Amendments to the Drawings:

REMARKS

FIG. 120F

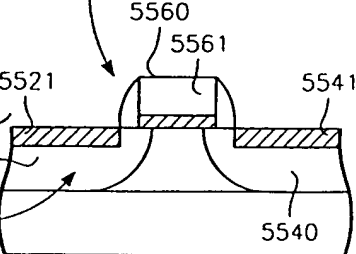
The attached sheet of drawings includes changes to FIG. 120F. This sheet, which includes FIG. 120A-120F, replaces the original sheet including FIG. 120A-120F. In Figure 120F, element numeral 5510 has been omitted and replaced with element numeral 5509, and element numeral 5520 has been omitted and replaced with element numeral 5519.

In amended drawing FIG. 120F, element numeral 5510 has been omitted and replaced with element numeral 5509. In amended drawing FIG. 120F, element numeral 5520 has been omitted and replaced with element numeral 5519.

Element 5520 deleted
5510c — Element 5510 deleted
5509 — Element 5509 added
5560
5561
5541
5540
5521
5519
5217
Element 5519 added
